Service Mitteilung

AE 4200 MC - 1. Oktober 2007

Seriennummern startend mit 065....

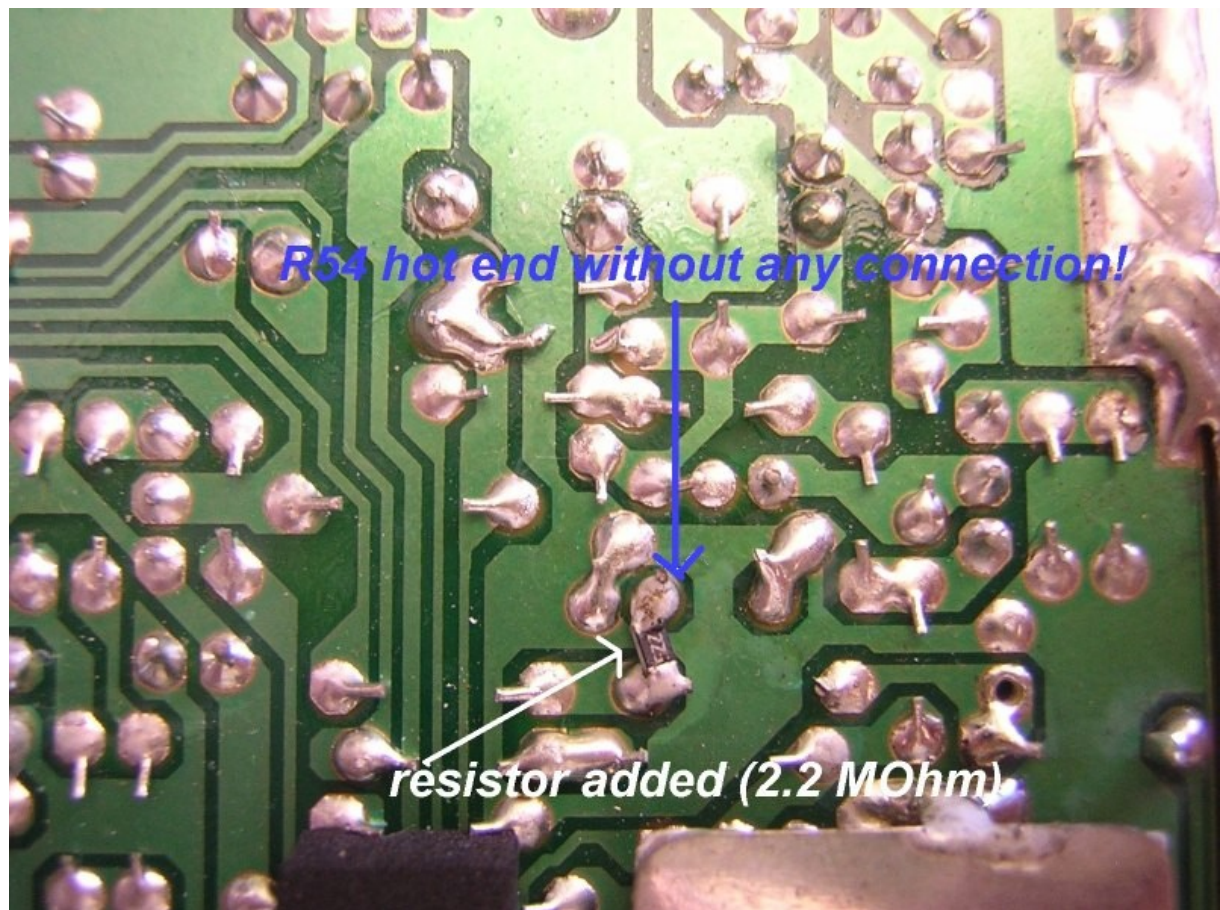
Ursache: Bei neueren Geräten ist Diode D 7 (zwischen VCO Käfig und Frontseite) eingebaut, ältere Geräte, die nicht betroffen sind, haben dort eine Drahtbrücke anstelle der Diode.

In Geräten mit Diode D 7 muss auch R 54 angeschlossen sein.

Leider wurde diese Verbindung bei einigen Geräten versehentlich nicht eingelötet. Wegen der Diode D 7 kann sich bei Empfang die (höhere TX-) Abstimmspannung der Kapazitätsdioden nur über Leckströme entladen, was je nach Gerät zwischen 1 und 10 Sekunden dauern kann. Während dieser Zeit sind die Vorkreise noch verstimmt, daher ist das Gerät für einen Moment noch unempfindlich.

Reason: in new AE 4200 MC versions, diode D 7 is inserted (located between VCO shielding and front side). Older units, which do not show the problem , have a jumper instead of D 7.

Radios with D 7 inserted must also have a connected R 54 resistor.

Unfortunately in some cases the connection of R 54 had been forgotten to solder in recent production. This will cause that the higher DC voltage level for the tuning diodes (during TX mode) will not discharge fast enough when switching from TX to RX. Depending on radio and PLL adjustment, this process can take between 1 and 10 seconds. During this time period the RX preselection filters may still be de-tuned.
